Joint Local Impact Report of
Cherwell District Council
Vale of White Horse District Council
West Oxfordshire District Council
Oxfordshire County Council

BOTLEY WEST SOLAR FARM (BWSF) REF: EN010147

June 2025

Transport Figure 1 - Wootton to NCN 5 connection

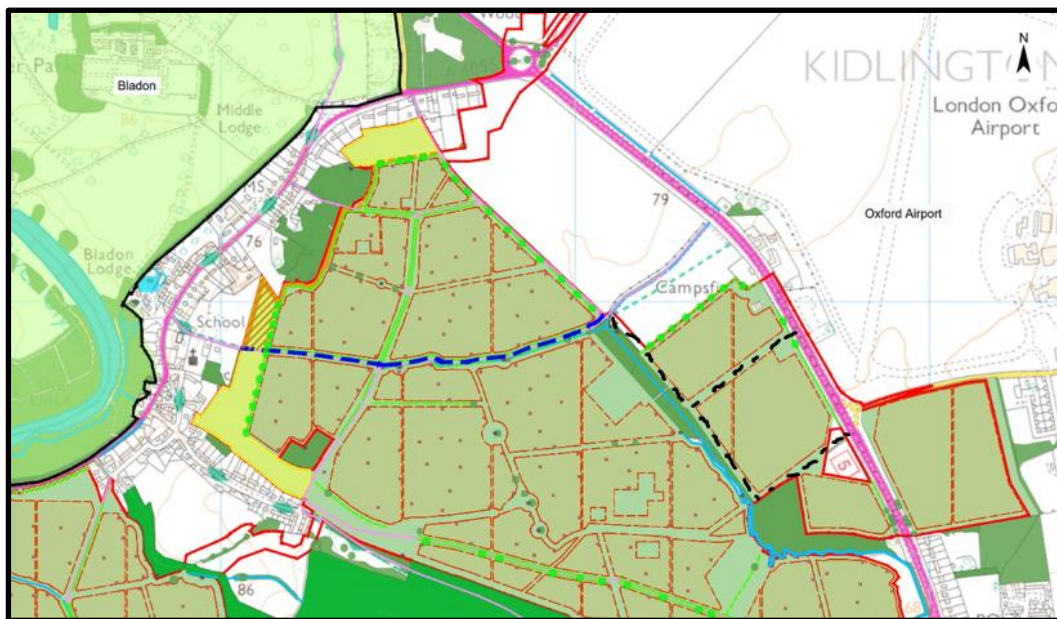
- 7.8.58 Whilst OCC welcome the Applicant's proposed walking and cycling route, which is indicated by the blue dotted line on Transport Figure 1 below, we consider it should be surfaced so that it is appropriate for walking, cycling and horse riding (e.g. by using compact gravel) and request that the Applicant confirms that this will be taken forward. In addition, the Applicant should provide the linking bridleway between 416/20/10 and 416/2/50 as indicated by the black line on Transport Figure 1, also using compact gravel or similar. This will enable safe and continuous connectivity between the public rights of way within the site and ensure the countryside can still be accessed and enjoyed.

Transport Figure 3 - OCC planned PRow route between Eynsham and Hanborough

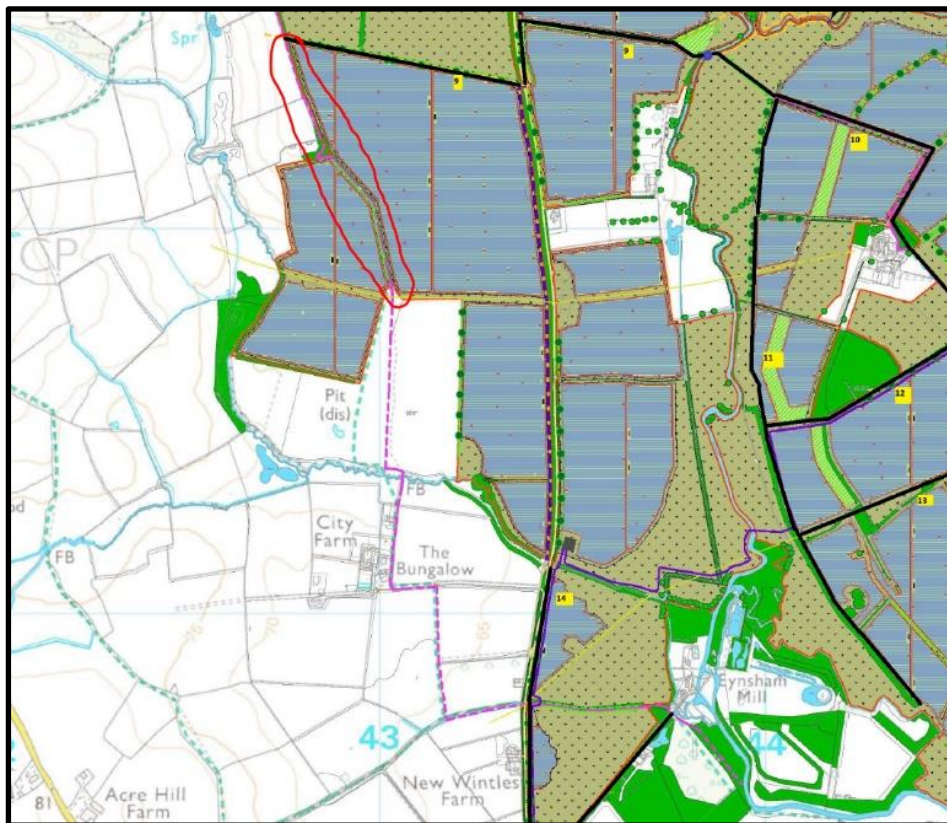
7.8.62 OCC request that the Applicant convert the section of PRow through their site (known as footpath 238/5/20), circled in red in Transport Figure 3 below, to a bridleway with compacted stone surface to seamlessly connect into other PRow improvements suggested by OCC. This will contribute to OCC's planned PRow connection between Eynsham and Hanborough and compensate current and future residents and visitors of the area for the negative impact on the landscape and 'countryside feel' that the solar farm would have.

7.8.63 In addition, OCC request that land along the western and eastern verges of Lower Road be safeguarded for future development of a walking and cycling route. The proposed route between Eynsham and Hanborough via Lower Road links in with the planned B4044 Eynsham to Botley cycle route. Both routes in part overlap with the proposed cable route for the solar farm.

Transport Figure 4 - OCC planned strategic walking and cycling connections

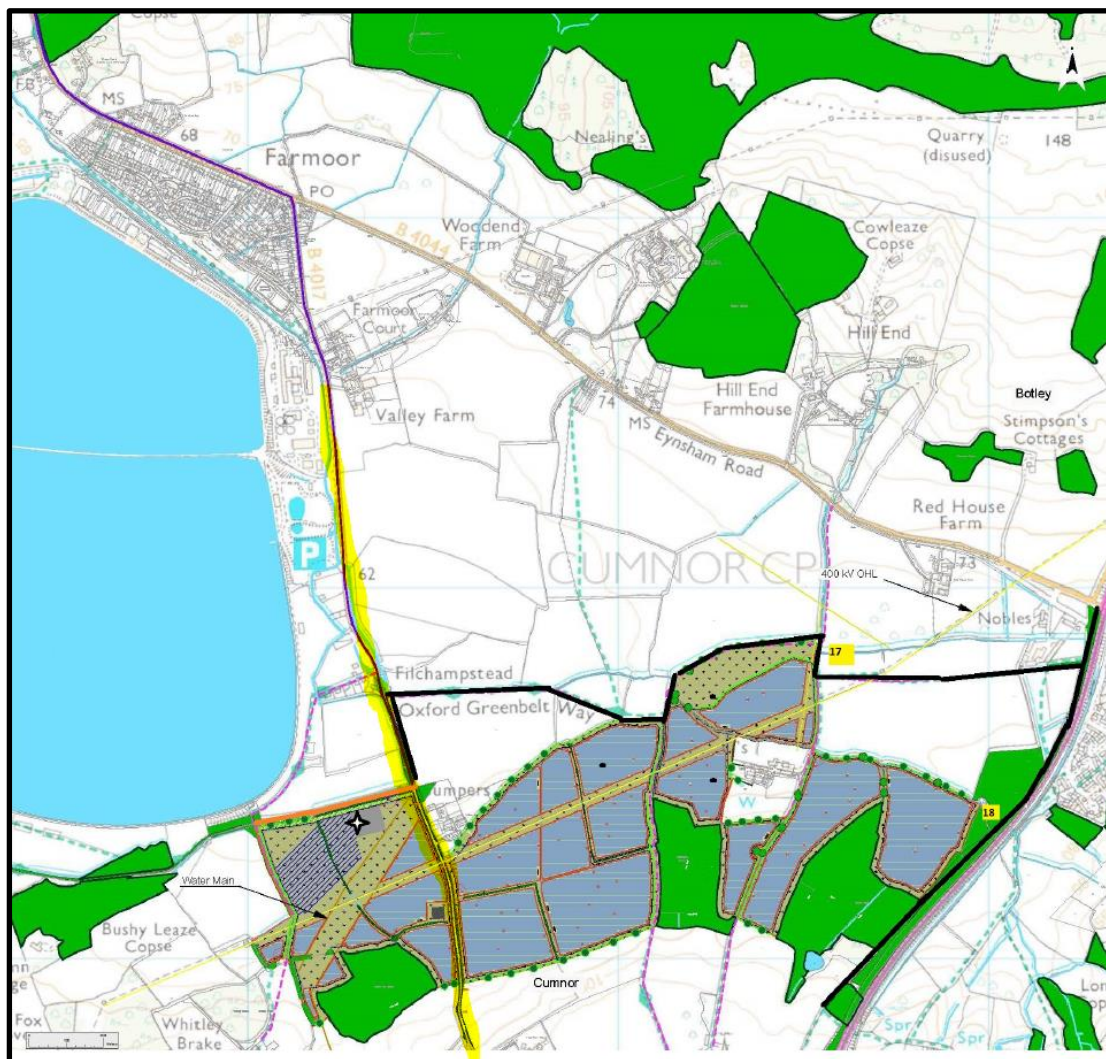
7.8.64 The Applicant has not finalised details of the cable laying, but if trenches are dug along the planned routes, a requirement of the DCO should be to agree details of their reinstatement to ensure compatibility with the future cycle path construction.

Figure 8.5 – Extract showing the National Landscape in pink hatch

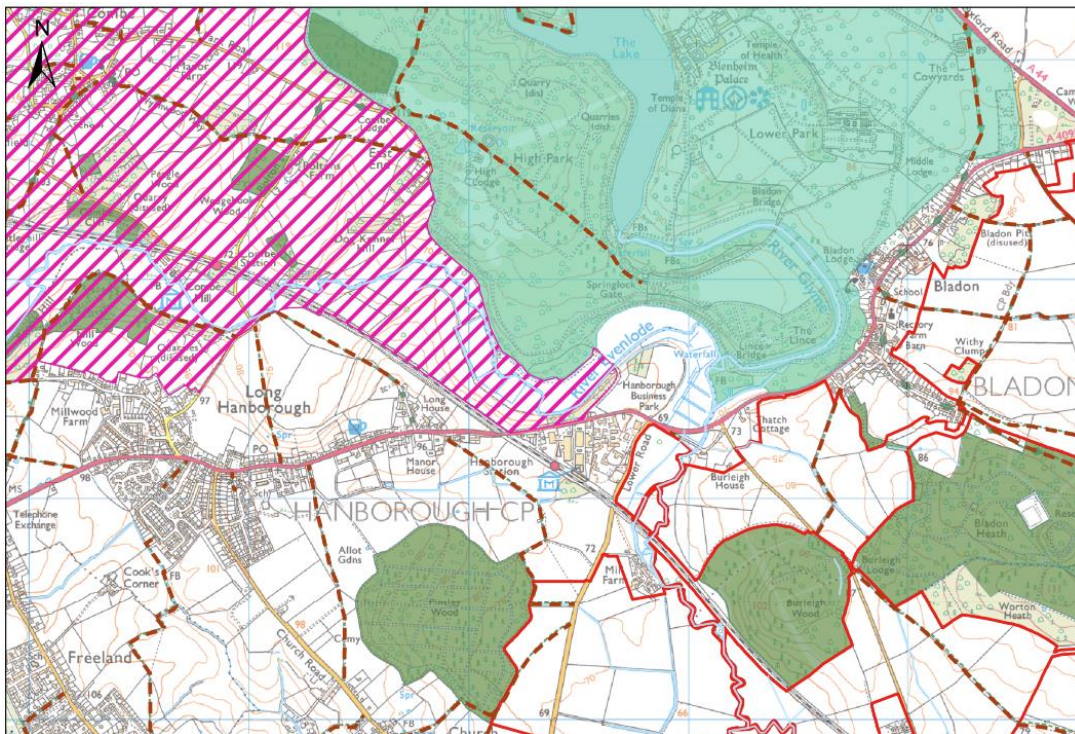
2.56 It would be helpful if reference was made to a ZTV map shown in combination with the National Landscape, and to a photomontage from this area, as the text itself is of limited help in terms of understanding the nature of the change as experienced from here. Reference to Figure 8.10 below suggests there is potential visibility of the project from Combe (Wychwood Way walking trail in the National Landscape) for example, which does not seem to be noted. Viewpoint 20 is near the National Landscape, to the west of the railway, from where there appears to be a clear view to the solar panels on the hills to the south east (*Figure 8.301 below*), the closest areas being some 733m away. The LVIA (paras 8.9.186-8.9.187) reports this as a ‘Minor’ adverse visual effect in winter during construction, and ‘Negligible’ by year 15. This judgement does not seem reasonable, and it is not possible to understand why the effect would reduce at year 15, given the view of the solar panels across the hillside would not be further obscured in any way. Given this visual effect will be clearly apparent (and appears to have been understated), and the indication of visibility on the ZTV from within the National Landscape, it is unclear why a representative viewpoint in this area of the designated area was not explored, so that the effects on the National Landscape could be fully understood, explained and illustrated. Whilst the photomontage makes the solar farm appear like a ploughed field in this view, on a clear day, or with a high resolution photograph, the change would be both extensive and very obvious.

Illustrative Masterplan Plan 02

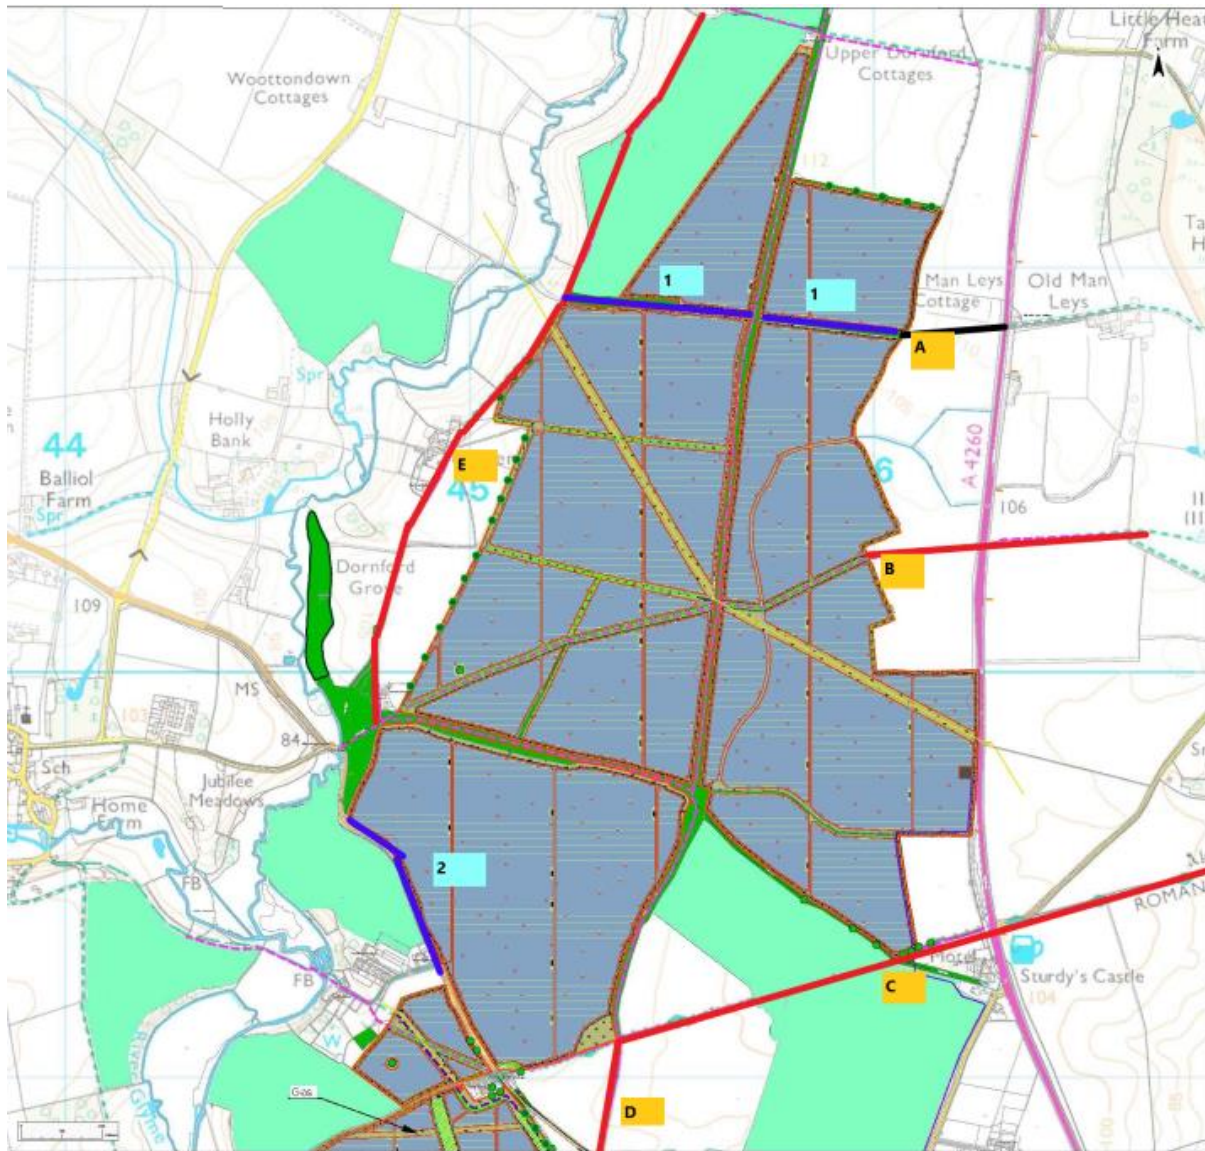
3. Onsite brideway connection	F. Upgraded path surface
4. Onsite footpath connection	G. Upgrade footpath to brideway to Woodstock Green Lane
5. Onsite footpath connection	H. Upgraded path surface
	I. Upgraded path surface

Illustrative Masterplan Plan 03	
6. Upgrade footpath to blacktop cyclepath 7. Improve surface of bridleway/cyclepath 8. Onsite new footpath	J. Upgrade footpath to blacktop cyclepath K. Upgraded path surface

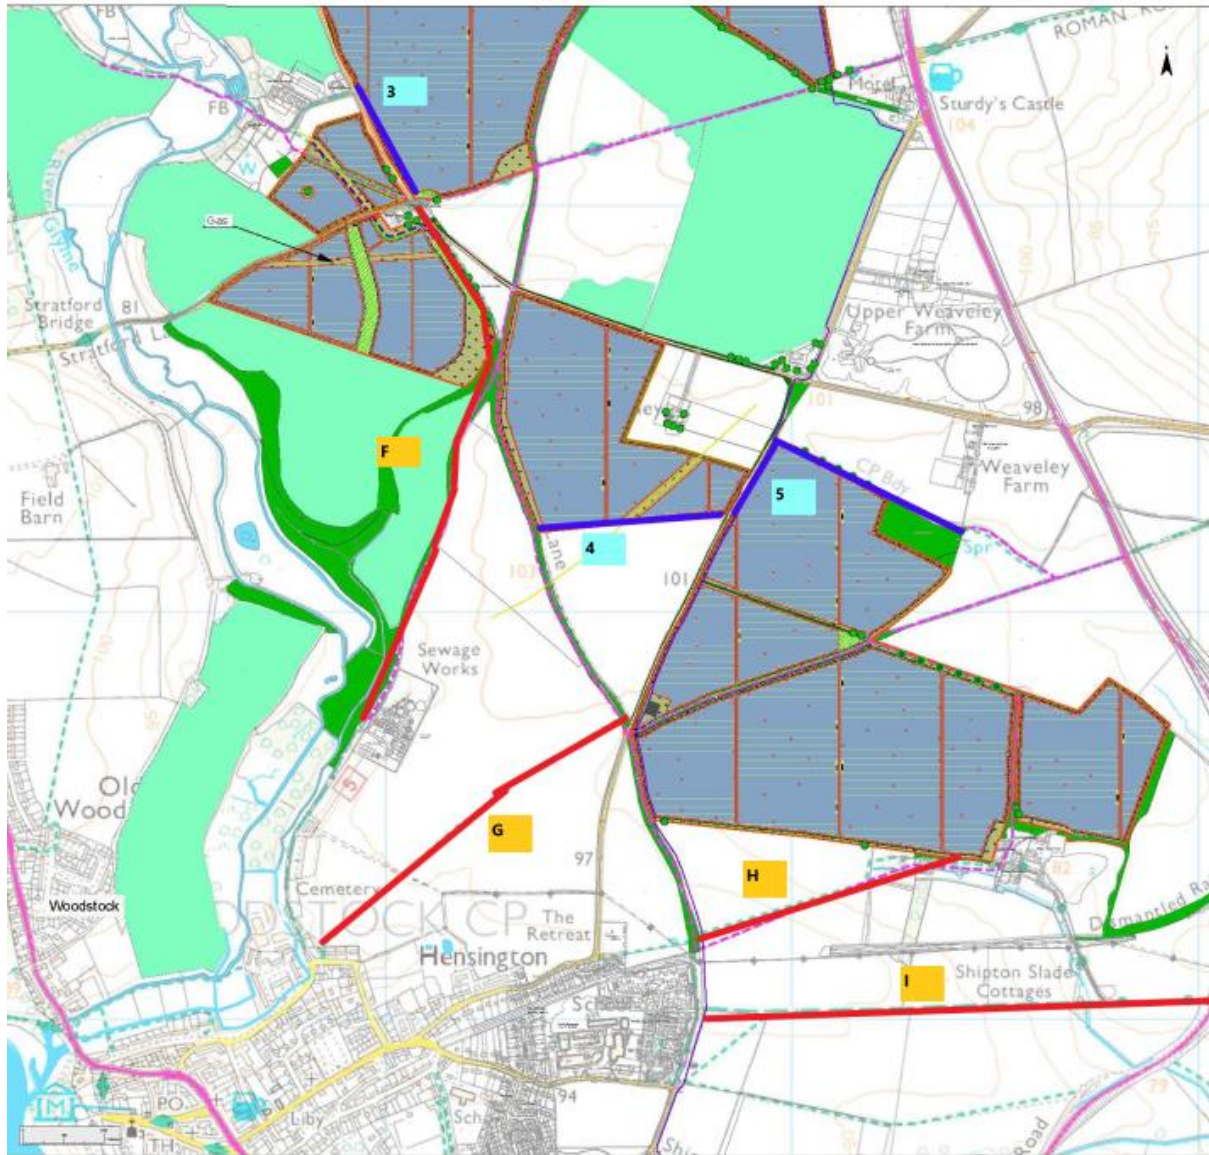
| J. Upgrade footpath to blacktop cyclepath |
| K. Upgraded path surface |

Illustrative Masterplan Plan 05

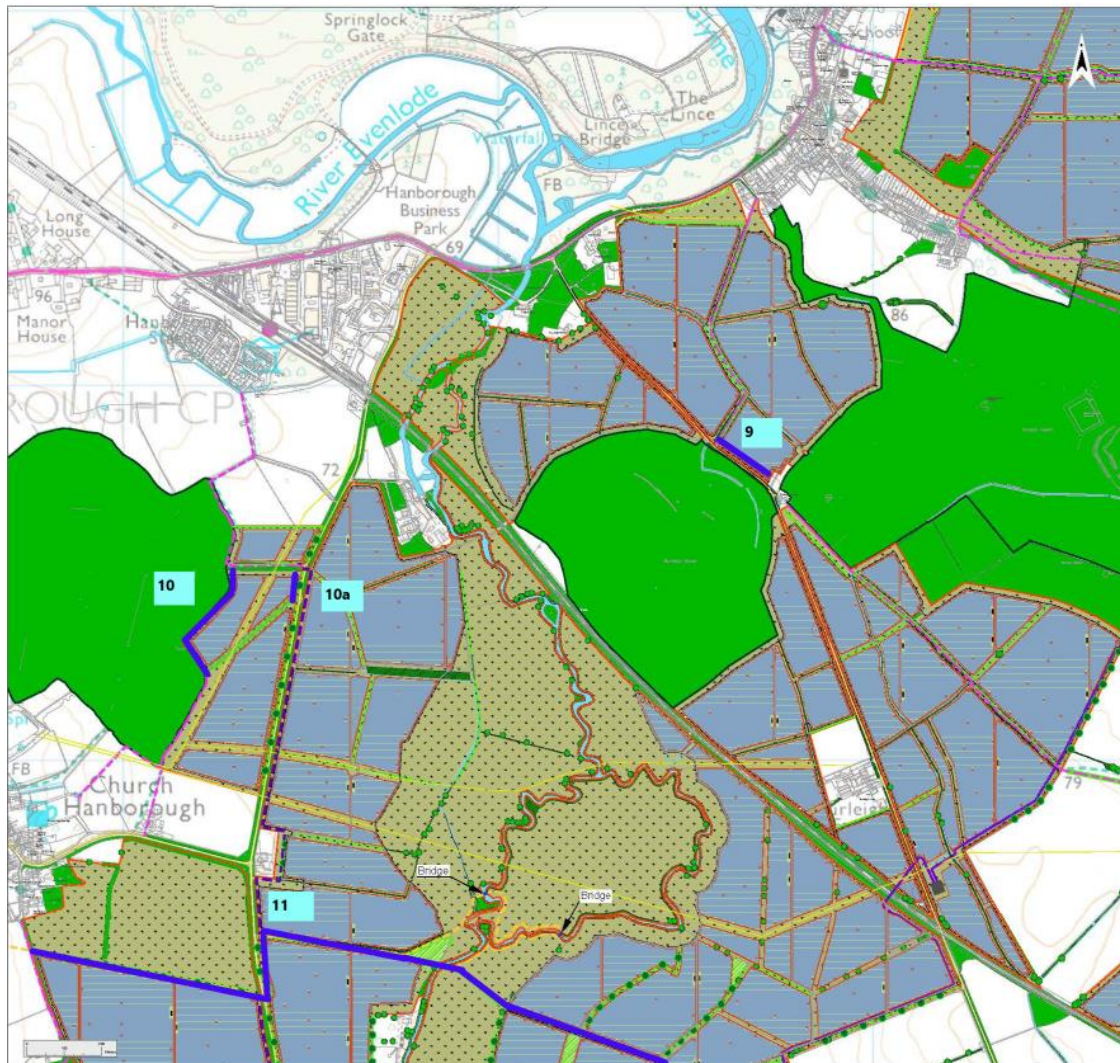
- 9. Linking footpath
- 10. Linking footpath
- 10a. Linking footpath (alternative)
- 11. Footpath upgraded to bridleway to Cassington (also on plan 5 and 6)

Illustrative Masterplan Plan 06

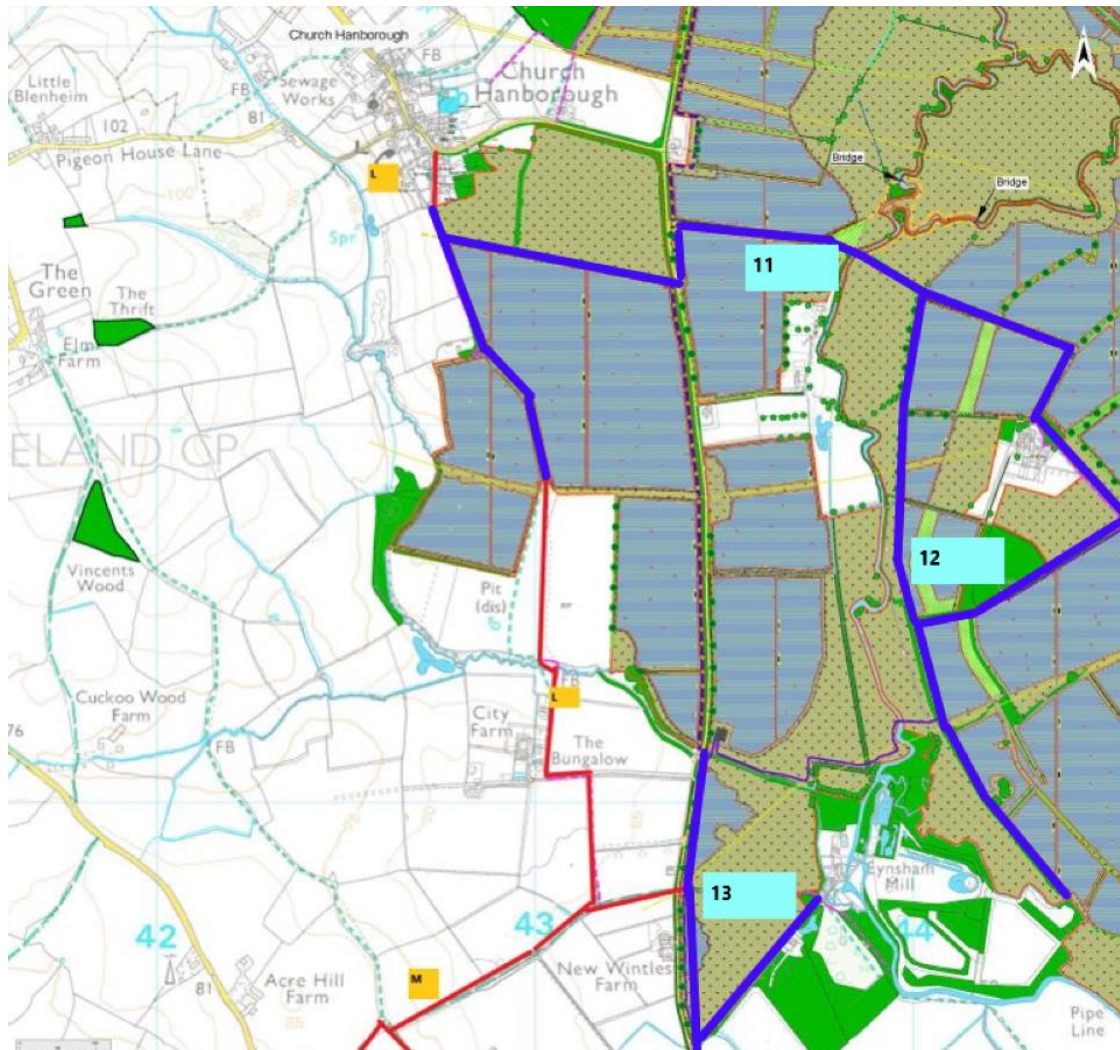
11. Footpath upgraded to bridleway to Cassington inc crossing	L. Upgrade to bridleway/cyclepath
12. Linking bridleways	M. Upgrade surface
13. Linking bridleways

Illustrative Masterplan Plan 07

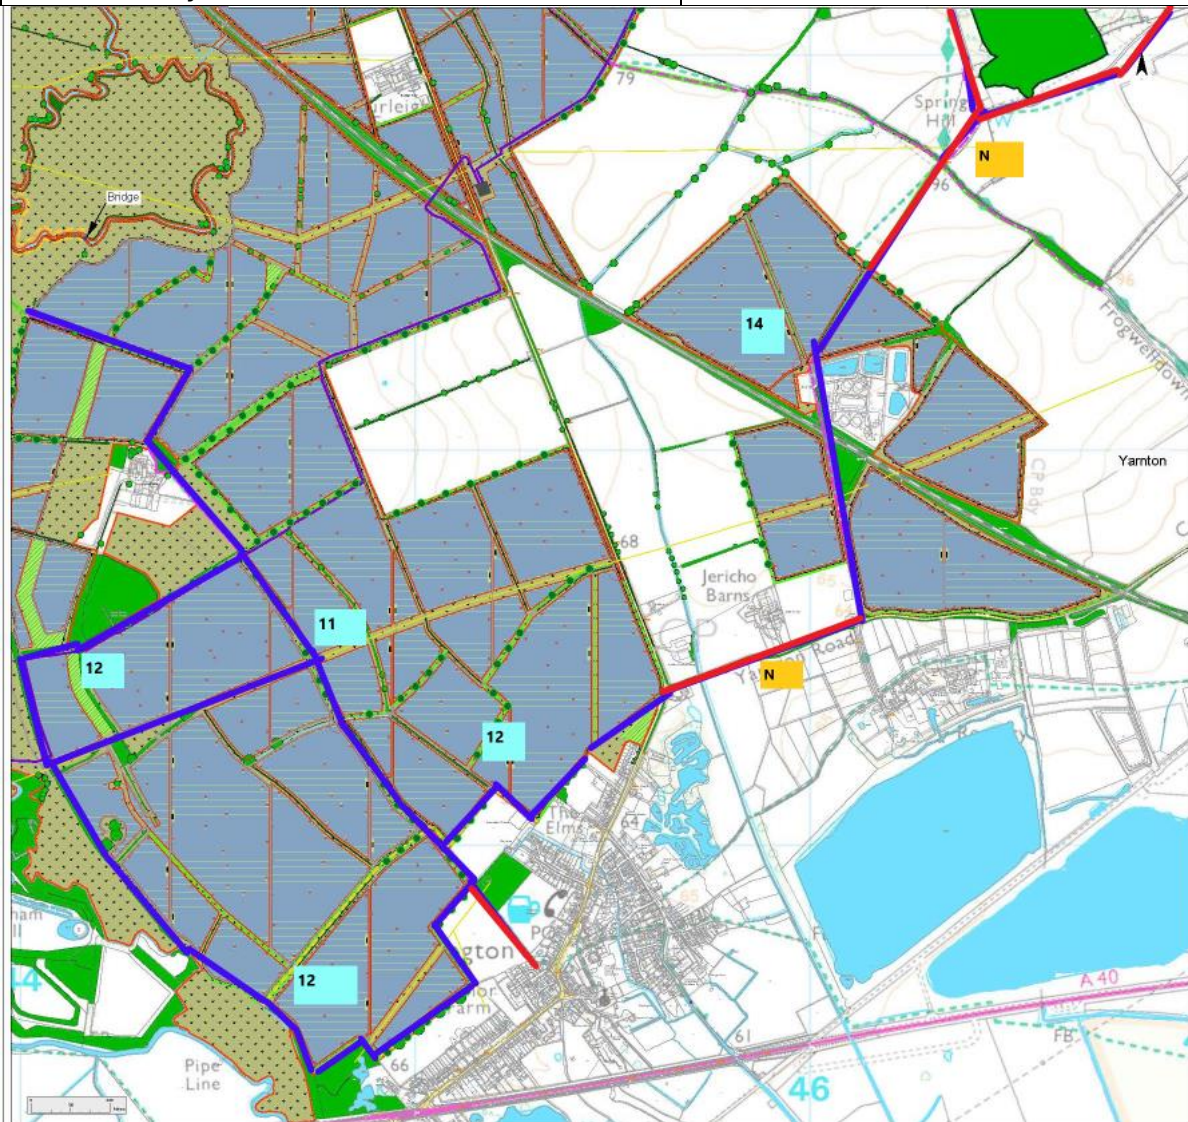
| <ul style="list-style-type: none"> 11. Continuation of upgrade brideway to Cassington 12. Linking bridlevays 14. Linking bridlevay and upgrading footpath to bridlevay each side of Begbroke Wood to bridlevay124/1 | <ul style="list-style-type: none"> N. Linking bridlevay and upgrading footpath to bridlevay each side of Begbroke Wood to bridlevay124/1 |
